Subject: Borg-Warner 3" and 4" Swing Check Valves

10 CFR PART 21 NOTIFICATION

(Reference No. CFRN-9301)

Texas Utilities, Comanche Peak Steam Electric Station.
Basic Component: 4-inch 150# Bolted Bonnet Swing Check Valve
BW/IP Part No. 75580
TU Tag Nos. 2CC-0697 & 2CC-0693

Required Angle of Disc Rotation and Axial Gap for Interference

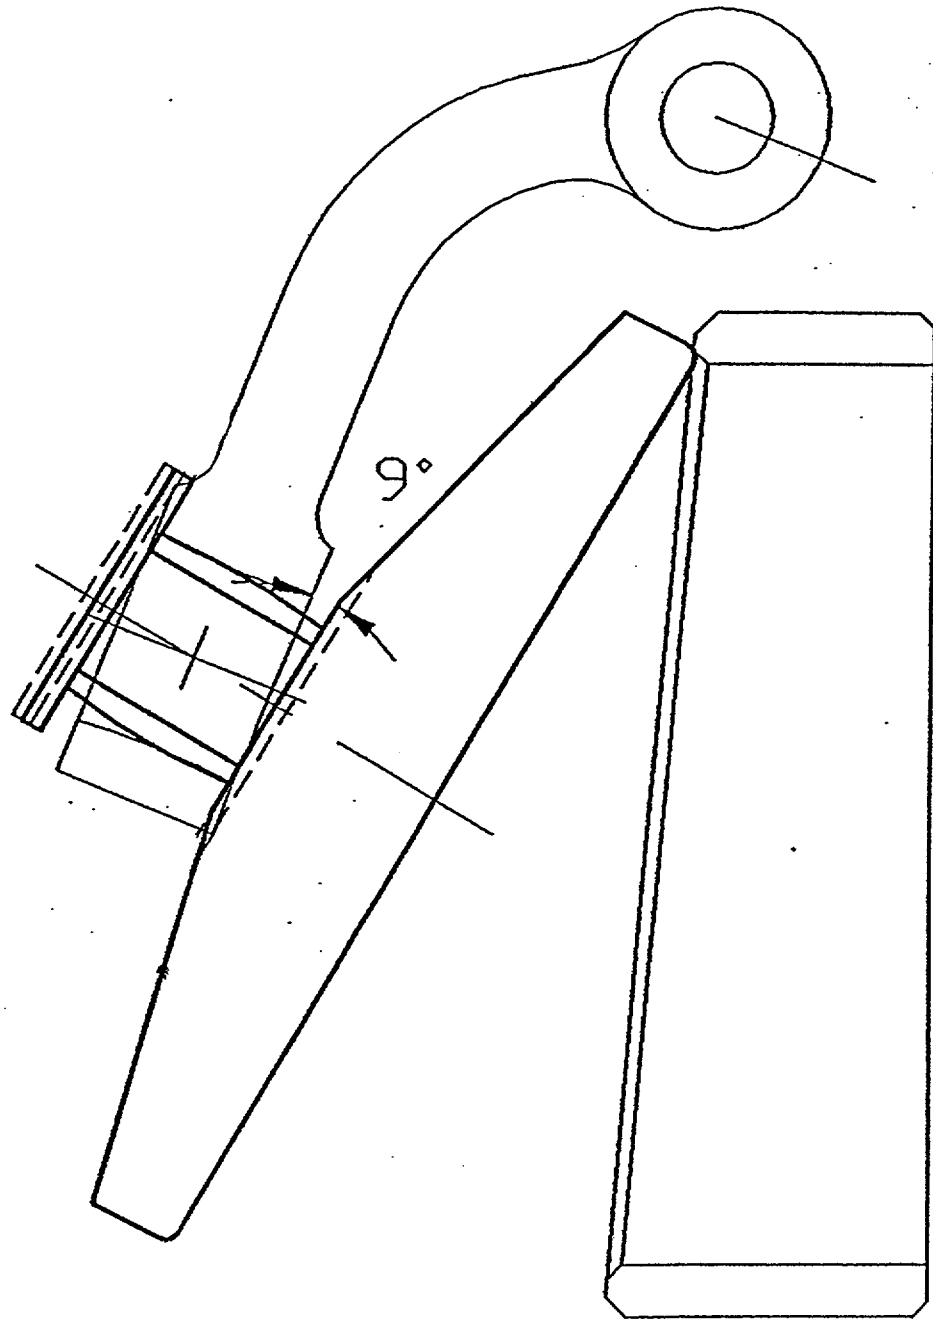
Valve 2CC-0697 did not fully close during pre-operational testing. Radiographs taken at the time of failure show the disk positioned at approximately 21° from the full closed position. The valve was disassembled. The top of the disk was found to be lodged under the seat lip preventing full closure. Valve 2CC-0693 subsequently failed testing in a similar manner. Both valves are located in the Component Cooling Water return lines from the Reactor Coolant Pump Motor Coolers and do not serve an active safety function. However the failure mechanism could apply to other valves that do provide a safety function.

Evaluation of the basic component by BW/IP indicates the root cause of the failure to close is due to the configuration of the attachment weld between the disk to the stud. Prior to 1977, this weld was placed on the back surface of the stud and extended into the bushing bore. In disks manufactured after 1977, the weld was recessed into the back surface of the disk and a final machine cut made to assure a flush surface.

This notice applies to all BW/IP 4-inch, 150#, bolted bonnet swing check valves which have a raised disk-stud retention weld on the back surface of the disk.

Corrective action is complete with the disk design modification identified above.

Licensees with valve installations effected by this notice should install a new disk component or refurbish the existing disk.
